Bardstown Road/Baxter Avenue Corridor Review Overlay (BROD) District

Report of the Urban Design Administrator to the
Committee

Case No: 19-OVERLAY-0018
Classification: Non-Expedited

Property Address: La Bamba, 1237 & 1239 Bardstown Rd
Applicant: Ralph Mendez
215 Candle Lake Drive
Divide CO 80814
Property Owner: A & M Real Estate Ptnr
1905 Glenn Park Drive
Champaign IL 61821
Project Cost: Not provided

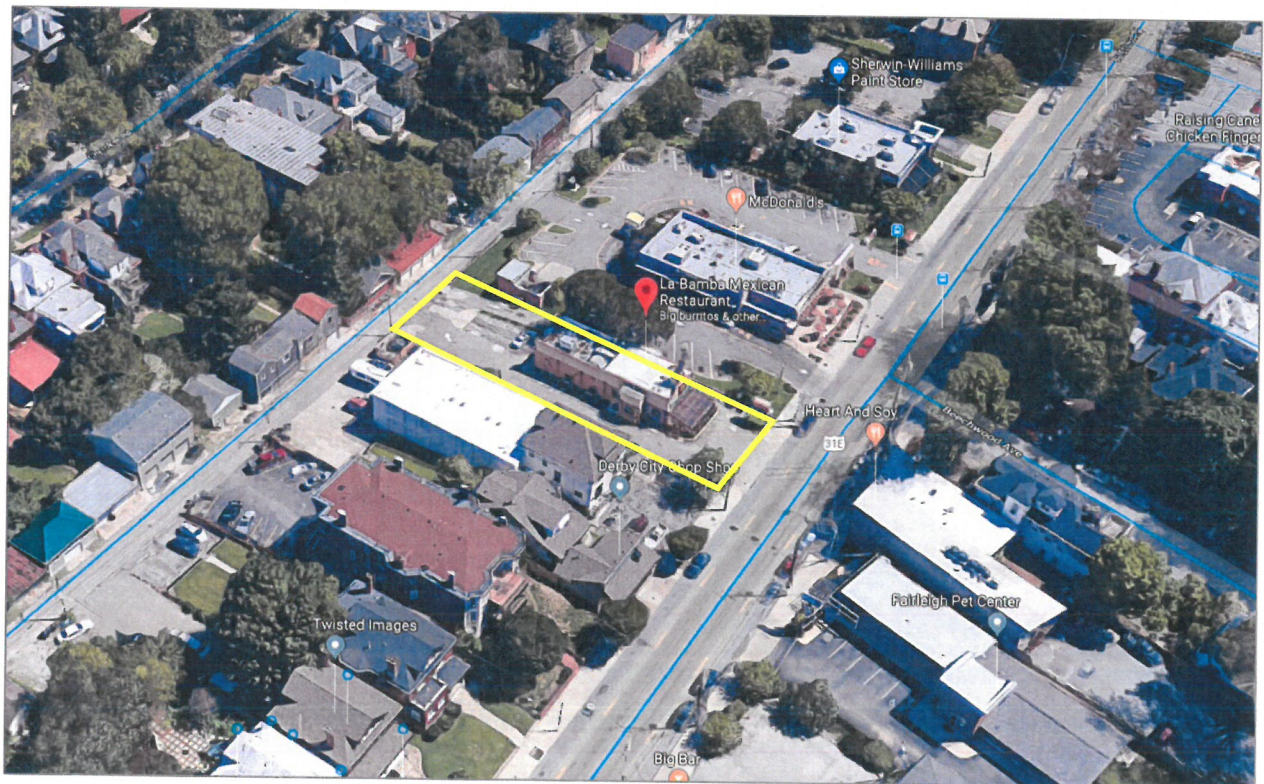
While the proposal includes only a single new building, its design produces the appearance of three attached buildings. The new building is contemporary in style and has architectural details that are common of other modern retail and restaurant projects. To reflect its utilization by up to three tenants, each of the three sections has a different architectural style, incorporating varying materials, features, and colors. The sections are 2,108 sq. ft. (front retail/restaurant space), 5,987 sq. ft. (front retail/restaurant space), and 1,326 sq. ft. (rear restaurant space). The front and rear sections are connected by an interior corridor and shared restrooms.

Unlike the existing building, 30' of the new building is located along the Bardstown Rd property line. This represents slightly less than half of the building's front façade. The remaining 32' of the building is set back 12' to allow for a 250 sq. ft. patio area and space outside of the public domain to accommodate the outward openings of the two sets of doorways.

To reduce its apparent scale, the new building incorporates several design elements, materials, and colors that reduce its massing and provide interest. While the exact materials were not provided, the materials shown on the renderings appear to include red brick (front), gray fiber cement or metal panels (front), and yellow stucco (rear). The aforementioned materials are not dispersed across all four facades and isolated to each section. The use of brick is consistent with many of the buildings in vicinity and the District. Stucco, EIFS, and fiber cement are also widely used; however mostly as an accent material in addition to brick.

While the inset portion of the building provides some variation to the front façade, it is important that this space be utilized for an activity that is encouraged by the Guidelines such as outdoor seating. In addition, the proposed front facade does not include a substantial architectural canopy or awning that extends over this patio. The inclusion of a canopy that extends further outward from the portion of the building set back will provide more variation and interest, as well as make that portion of the building appear closer to the street. It is also important that the seating area is a defined space. The renderings show planter boxes surrounding the seating area.

There are three canopy-style awnings projecting from the new building above the main entrances to each of the three sections. The canopies are the only common element used throughout the building to help tie the three architectural styles together into a cohesive, unified design. While the styles used in the front section are both contemporary and compatible, the rear section has a significantly different architectural style and coloring that makes it substantially contrast from the other sections. While the use of the different styles helps break up the mass of the building and adds some interest, it is important that the styles are compatible given that they have the resemblance of attached buildings. The use of harmonious colors and design features may assist in improving the compatibility.

On the windowless northwestern façade, a conceptual mural is shown on the renderings. Staff strongly encourages that a mural or other public art be applied on this relatively blank wall. To help ensure that any public art is appropriately integrated into the project and the District, the applicant should work with the Public Art Administrator prior to the painting of any mural or installation of other public art.

Considering the information furnished, the Urban Design Administrator recommends **approval** of the application for an Overlay Permit with the following conditions:

1. Finalized design details and materials shall be submitted to staff for final review and approval. If the design or materials change, the applicant shall contact staff for review and approval prior to installation.

3. Design elements shall be utilized in the front patio area to facilitate and encourage use as outdoor seating. Elements can include, but are not limited to, seating and the use of planters and a canopy to provide definition.

4. Public art is always encouraged to enhance the quality and design of projects in the district. Any public art proposals should comply with the Public Art guidelines and shall be submitted to staff for review and approval.
